Preliminary Environmental Review Kwai Chung Crematorium

Final Report

**Preliminary Environmental Review
for Kwai Chung Crematorium**

Preliminary Environmental Review (PER) for
Kwai Chung Crematorium

Figure 2.1 Site Location Map of Kwai Chung Crematorium

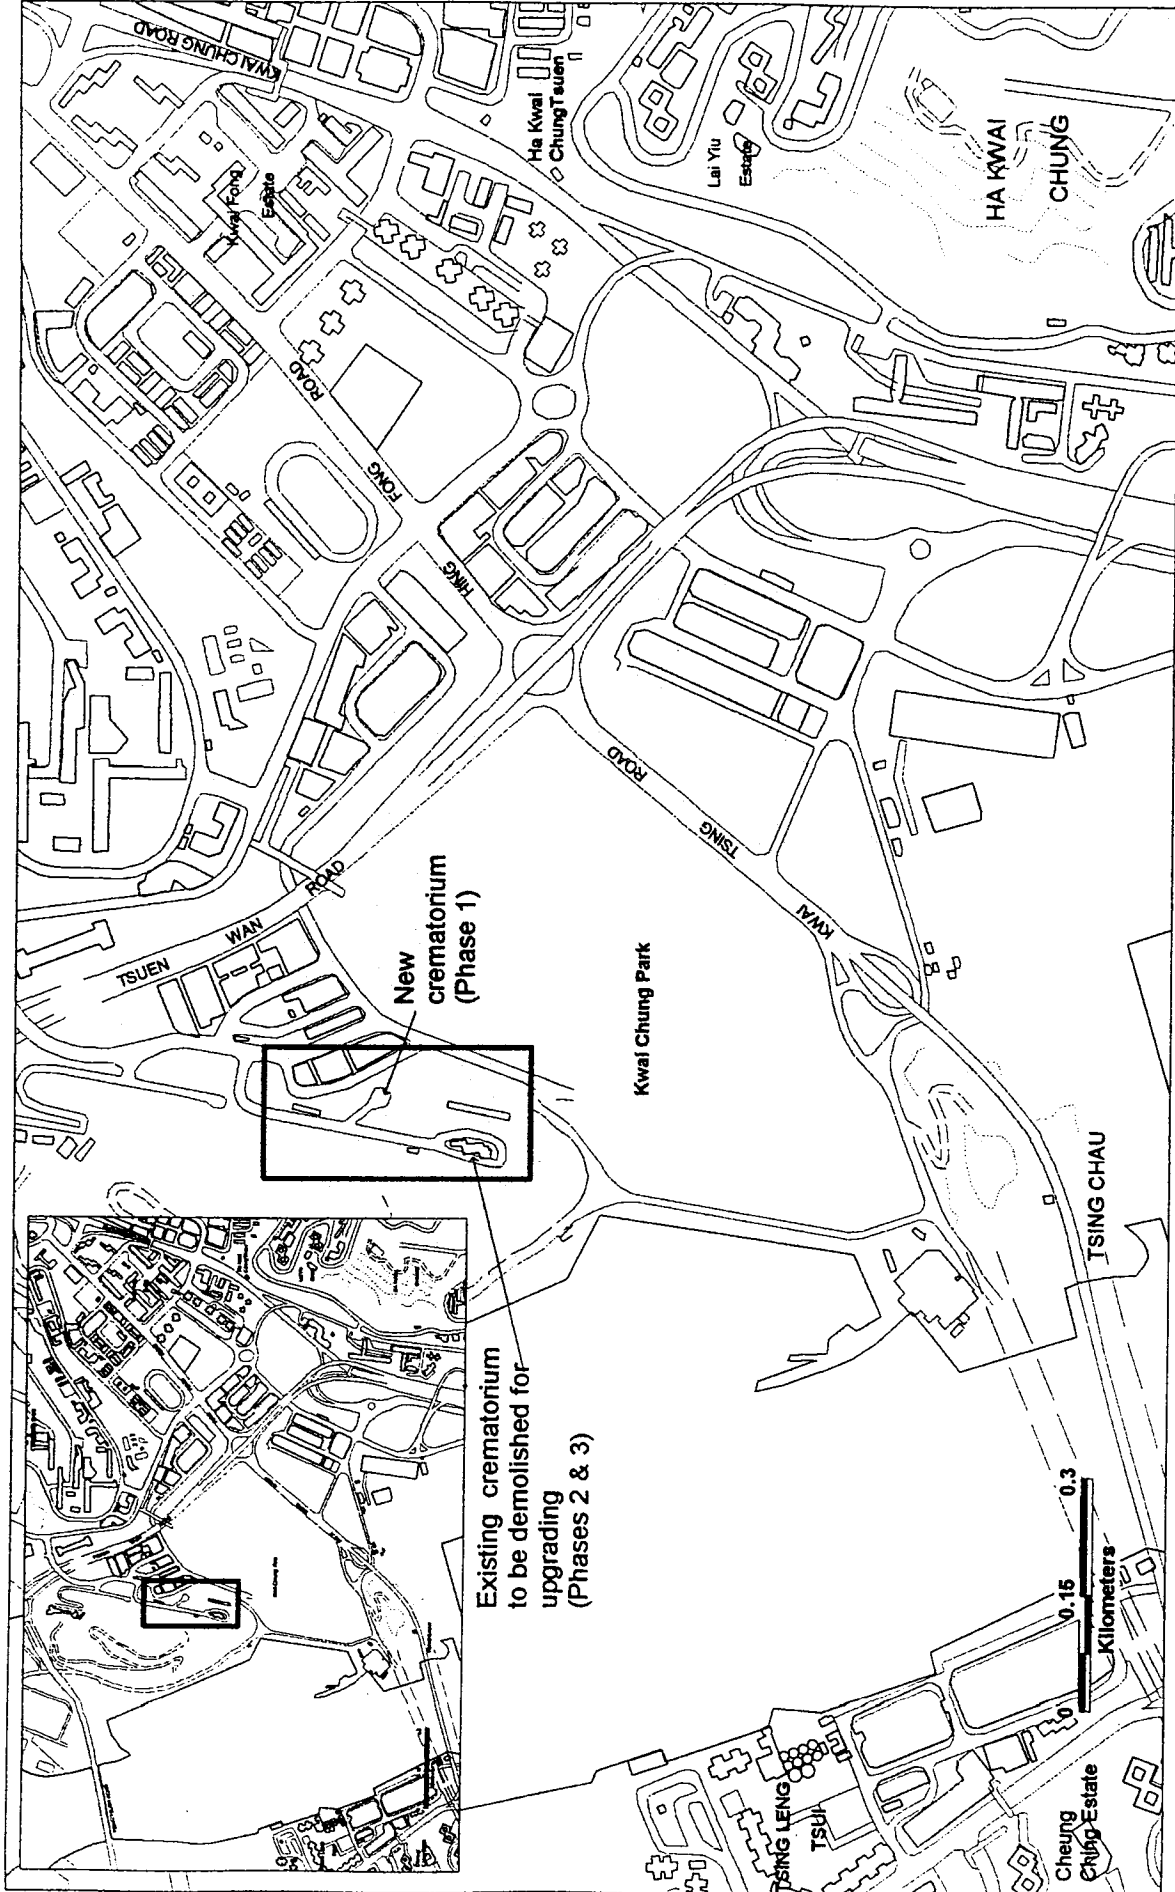
- (i) Section 2 - The relative location of the existing crematorium, the new crematorium should be shown in Figure 2.1. ✓
- (ii) Section 3.2
 - (a) The study "Crematoria Air Quality (CAQ)" report mentioned in this section should be attached with the ER for our reference. ✓
 - (b) Please note that a specified process licence will be required for the operation of all the cremators in the crematorium, not just the new cremators. This is particularly applicable to the transitional situation where the construction of the new cremators in the Phase I development is completed but the Phase 2 demolition work is yet to start and the existing cremators are still in use.
